SYDNEY WESTERN CITY PLANNING PANEL

COUNCIL ASSESSMENT REPORT

SSWPP No	PPSSWC-114
DA Number	DA-836/2020
Local Government Area	Liverpool City Council
Proposed Development	<p>Development Application (DA-836/2020) seeks detailed consent in accordance with approved Concept Proposal (DA-585/2019) for Stage 2 (Phase A) of the 'Liverpool Civic Place'. The proposal includes:</p> <ul style="list-style-type: none"> • Construction and use of six (6) storey information and education facility (public library); • Construction and use of fourteen (14) storey mixed use building comprising public administration, childcare and commercial office uses; • Construction of a five (5) level basement, that will accommodate car, bicycle and motorbike parking; • Landscaping and public domain works; and • Extension and augmentation of services and infrastructure as required.
Street Address	40-46, 48, 52 and 64 Scott Street, Liverpool 306-310 Macquarie Street, Liverpool
Applicant/Landowner	Built Development Group

Report date	14 June 2021
--------------------	--------------

Figure 13: Staging of the proposed public domain

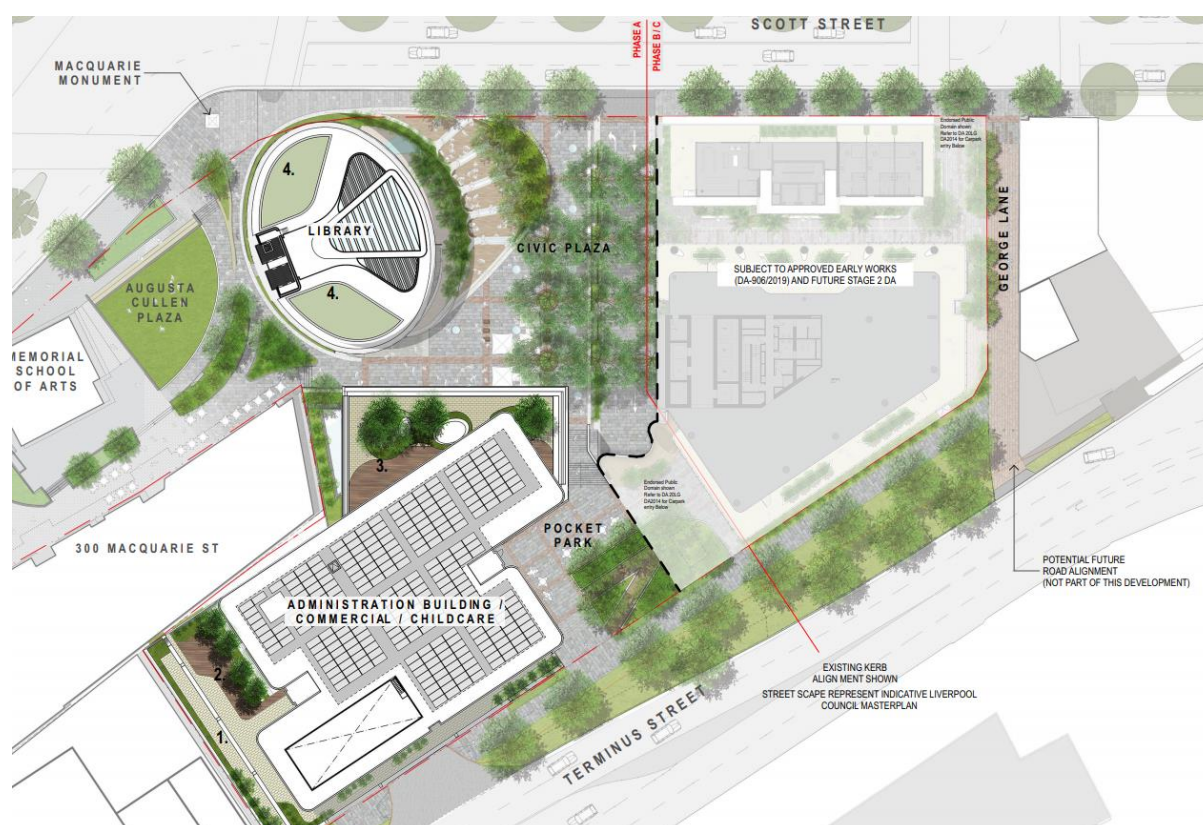
- *Further, it would be helpful to understand how the public domain will be treated during the different stages of the overall concept plan until development is completed.*

Comment: The Public Domain will be delivered in stages. Phase A will develop the public domain up to and including the proposed shared zone. Land to the east of the shared zone will be delivered under Phase B/C development (DA-1080/2020). This is shown in the Figure 13 below.

Figure 37: North elevation (location of variations shown in red)
Source: FJMT Architects

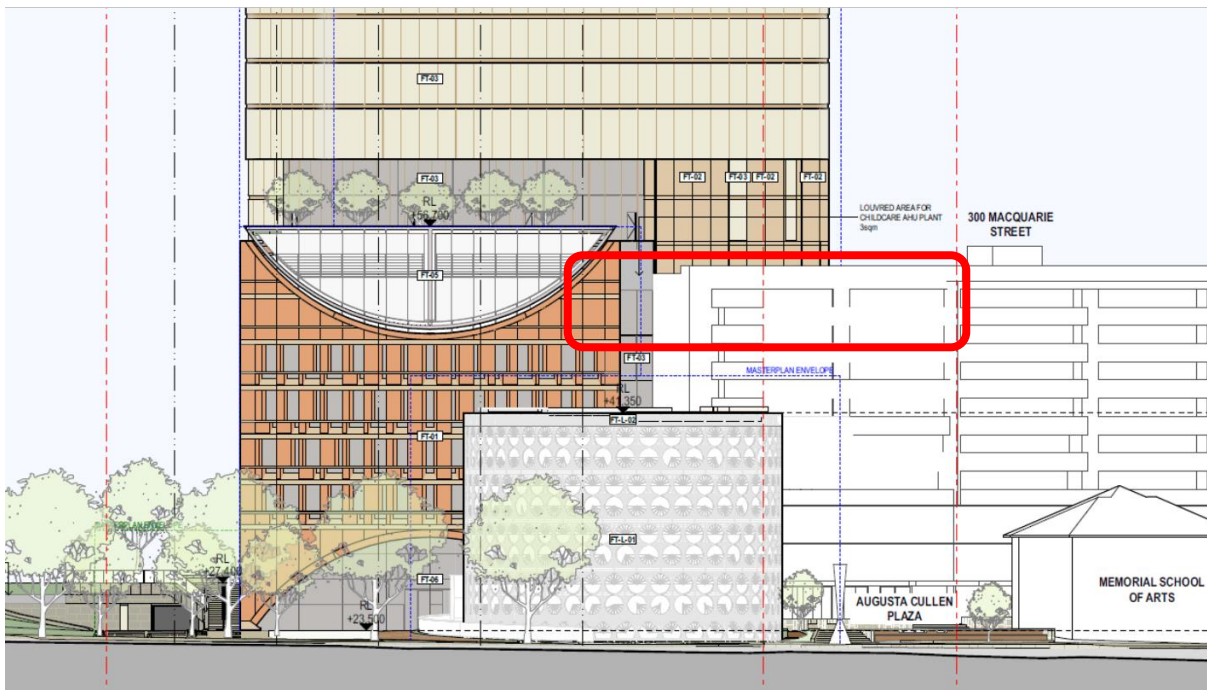
Portions of the proposed development do not comply with the 12m building separation required under Clause 7.4 (refer to Figure 36):

Figure 39: Façade with privacy treatment to 300 Macquarie Street

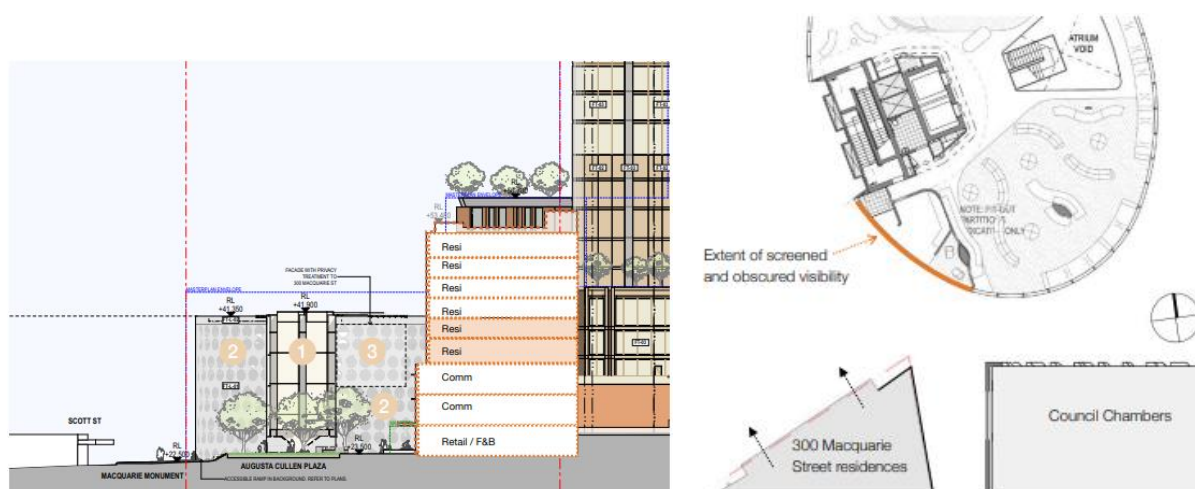
Privacy and Light glare - *There needs to be a fix screen to the library to protect privacy and light glare from the extended hours of a public building (library) to the residential apartments which directly face the new library building.*

Comment: The applicant has considered the impact on 300 Macquarie Street through the façade treatment. The proposal has considered the need to locate heavily used areas within the library away from 300 Macquarie Street. In terms of privacy, the upper two levels will be provided with fixed screening to obscure vision from the library interiors and preserve privacy to the residential neighbours. See below Figures 39.

Figure 40: Existing ramp shown on the left and proposed ramp shown on the right

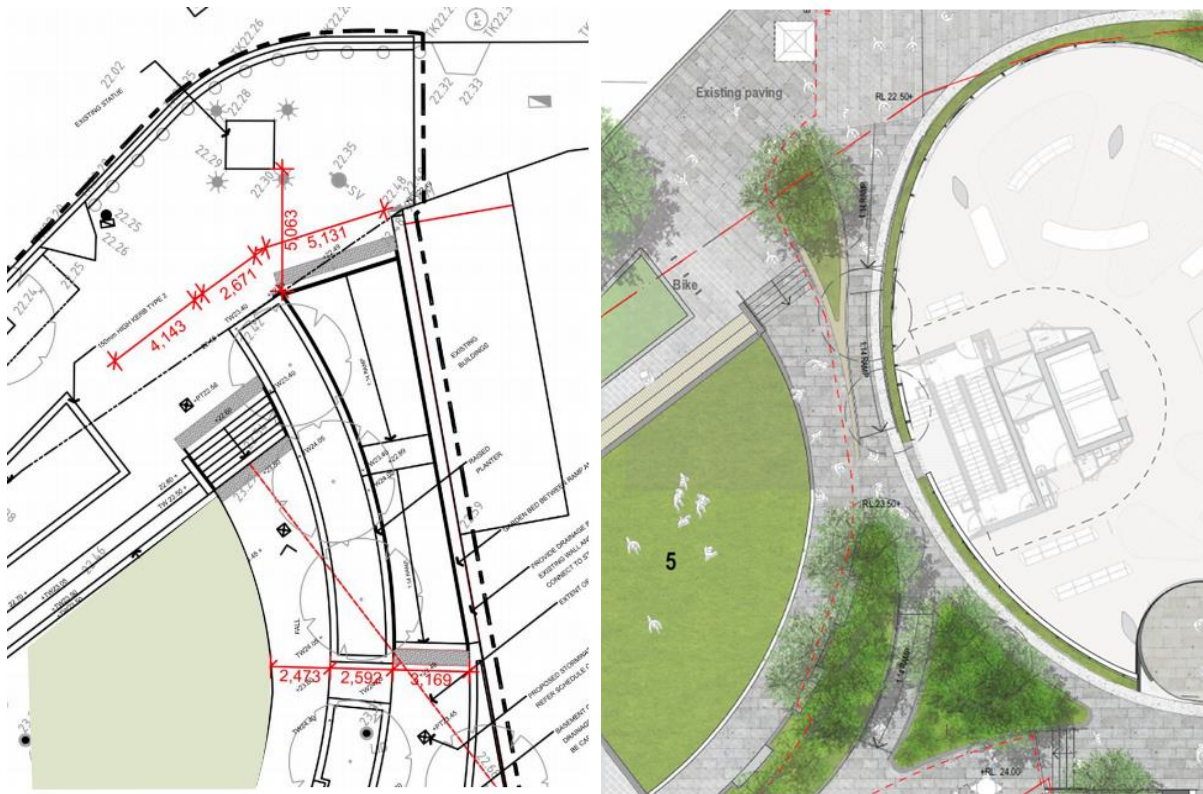
Access - *The plans which are available online does not clearly illustrate the connection of the ramp that is being removed as part of this proposal. This ramp provides formal entry and disabled access to 300 Macquarie Street. The proposal should provide a minimum width of 2m (ramp) to replace the existing ramp between the library and the open space.*

Comment: In response, the applicant has provided a replacement ramp that is proposed to retain access to 300 Macquarie Street from Macquarie Street. The ramp is to be a width of 1.8m that widens to approximately 5 metres at the street frontage of Macquarie Street. An access consultant engaged by the applicant has confirmed that width of ramp would be adequate.

Figure 41: extract from upper ground level plan showing disabled accessway between the site and Augusta Cullen Plaza and the forecourt of 300 Macquarie shown in red, and stairway shown in blue

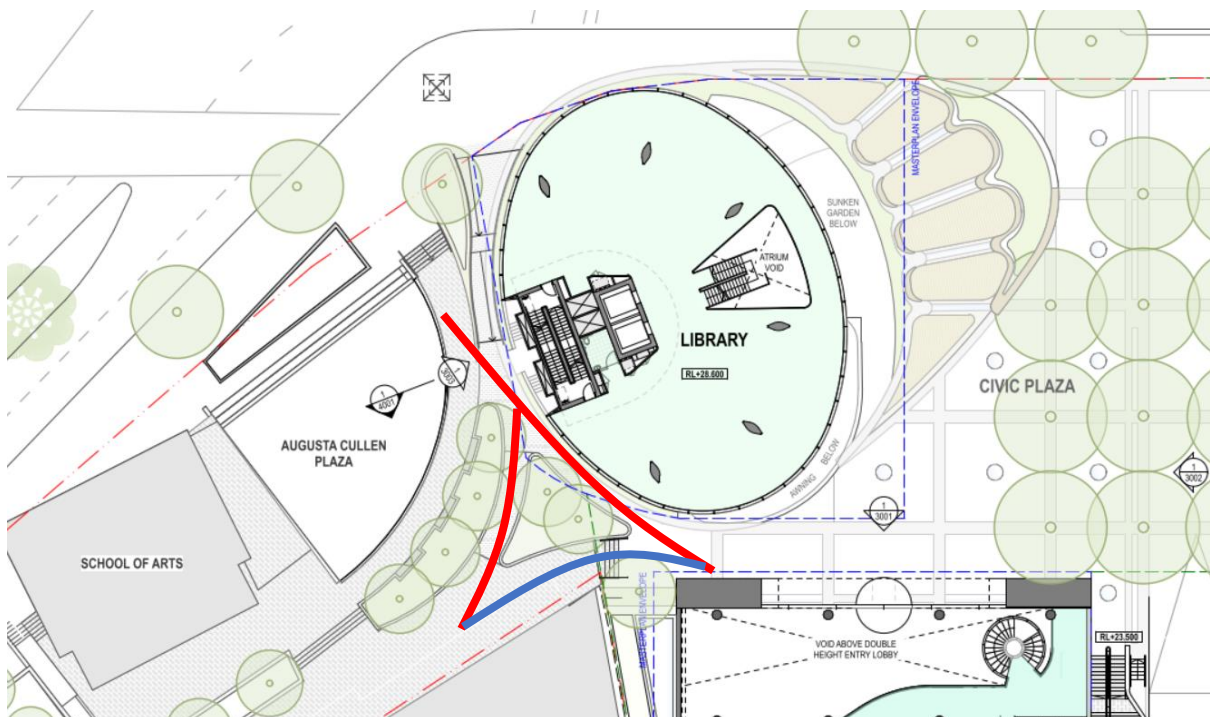
Augusta Cullen Plaza - It appears that there is only a set of stairs which allows access from the new public domain to the forecourt of 300 Macquarie Street. If Augusta Cullen Plaza is to be used as an informal park, then it is unclear as to how connectivity from a disabled access perspective is being provided.

Comment: In addition to the set of stairs, a walkway and ramp provides access from the library and civic plaza to 300 Macquarie Street retail forecourt and Augusta Cullen Plaza. The walkway is 1.6m and the ramp is 1.8m wide.

Figure 42: West elevation of library with Augusta Cullen Plaza in foreground

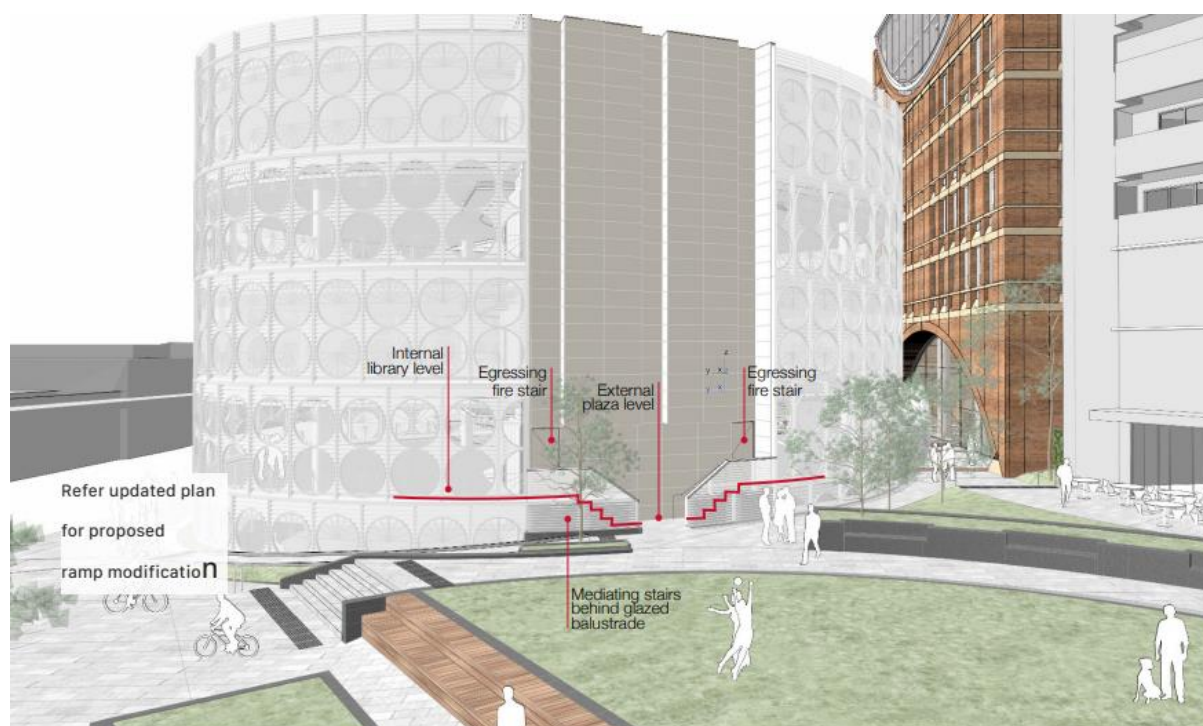
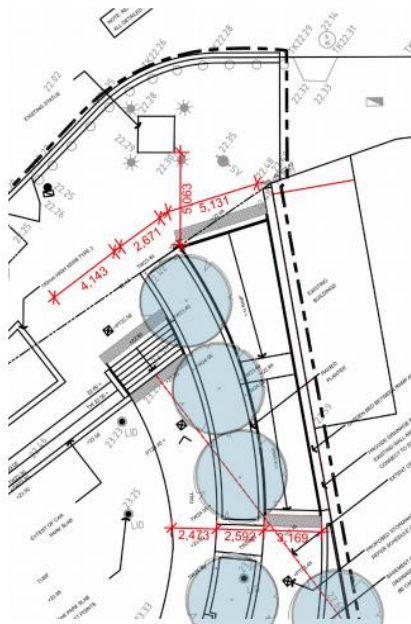
Fire Stairs - There was a concern which related to the location and detailing of the fire stairs and how that interfaces with Augusta Cullen Plaza. It is requested that there is separation via a gate or door that better integrates this element from a design and crime prevention perspective. At the moment the plans appear to show an area one can hide behind.

Comment: It is noted that the internal floor level does not match the Augusta Cullen plaza floor level, so external stairs are required to mediate the level difference. It has been proposed by the Applicant, that the external stairs will be positioned within the oval footprint of the library and the façade wraps these stairs to present a neat elevation treatment to the plaza (see Figure 42 below). The wrapping facade is low and mostly transparent. This design outcome is considered appropriate.
